**AGENDA  
PLANNING COMMISSION MEETING  
CITY OF SHOREVIEW**

**DATE: DECEMBER 06, 2011  
TIME: 7:00 PM  
PLACE: SHOREVIEW CITY HALL  
LOCATION: 4600 N. VICTORIA**

**TO:** Planning Commission  
**FROM:** Rob Warwick, Senior Planner  
**DATE:** December 1, 2011  
**SUBJECT:** File No. 2436-11-29; Variance, Caroll Roberts, 200 Dawn Avenue

**SUBJECT:** Variance and Residential Design Review, Alan and Heather Woldt, 800 County Road I, File No. 2435-11-28

**SITE PLAN FOR PAT & JACKIE O'CONNELL**  
SHEET 1 OF 1

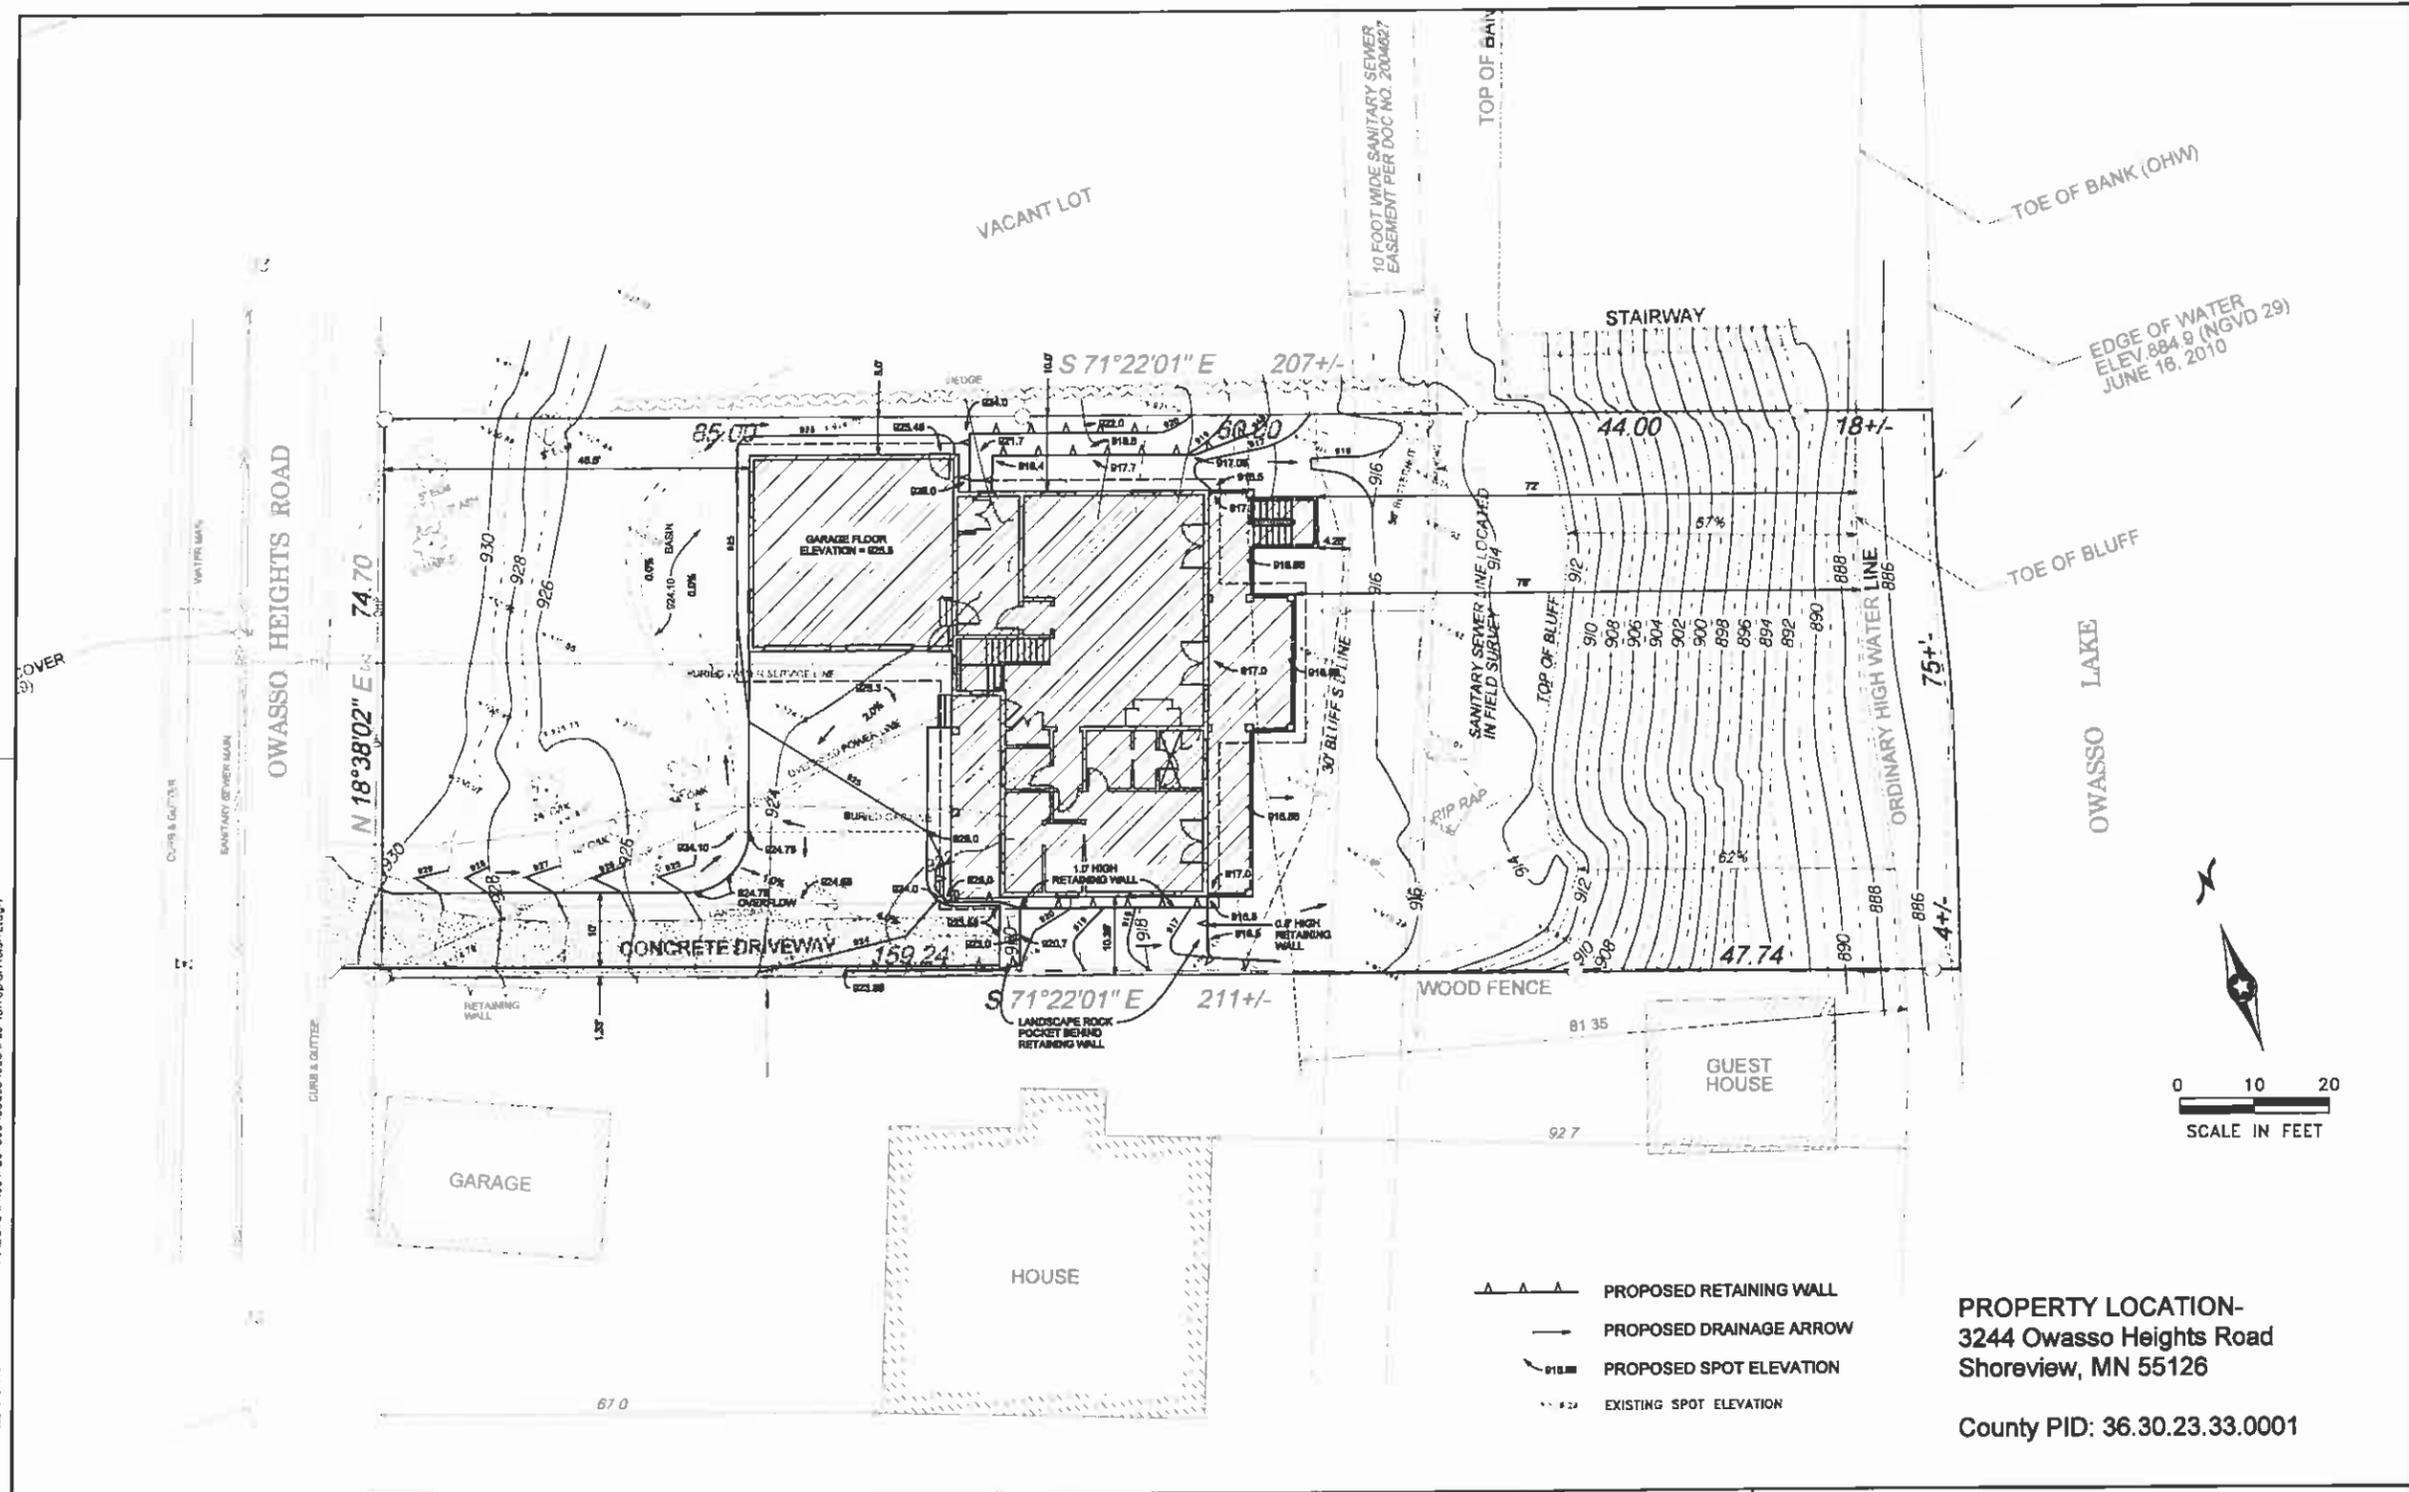
- 1) **Water run-off.** 3244 can slope into our property (southside), and at times water has caused damage and leaking (in our 1929 boathouse), despite many efforts on our side including gutters, retaining walls, and plantings—and efforts by 3244. Our hope is that the renovation will include considerable attention to this on-going risk, especially on the lakeside hill—where a gulley has formed and the plan appears to contain a rock “dry creek.”

- 2) **Driveway on the property line.** Presently, 3244 includes a driveway that runs from the street to the lakeside (eastside) of the house, directly on the property line. The plans appear to replicate this feature, with no changes for setback, water control, or vegetation. If possible, we welcome consideration of other possible solutions that might increase privacy for all parties, improve run-off management, and reduce noise by our bedroom. Is there no code regarding this? A setback space might also benefit the oaks, shrubs, and other plantings, as noted below. It is also unclear whether the driveway will be paved or not, and what surface will connect the driveway to the upper, double garage.

- 3) **Oak tree care.** Three or four oak trees stand close to the property line on our side, and are likely to suffer damage from demolition, digging, heavy trucks, and more. (Elsewhere on our property, we already have two dying oaks undergoing expensive treatments for damages related to construction projects.) So we simply request careful treatment of the trees and root systems, for the benefit of all properties, and again question a driveway on the property line running about three-fourths the length of the property.

As per our discussion, the proposed grading plan does address run-off from the site and driveway by directing it into low areas and well defined swales on the property and away from adjacent properties. I would suggest that the owner leave the concrete driveway in place during construction to act as a construction entrance and keep material from tracking into the street.
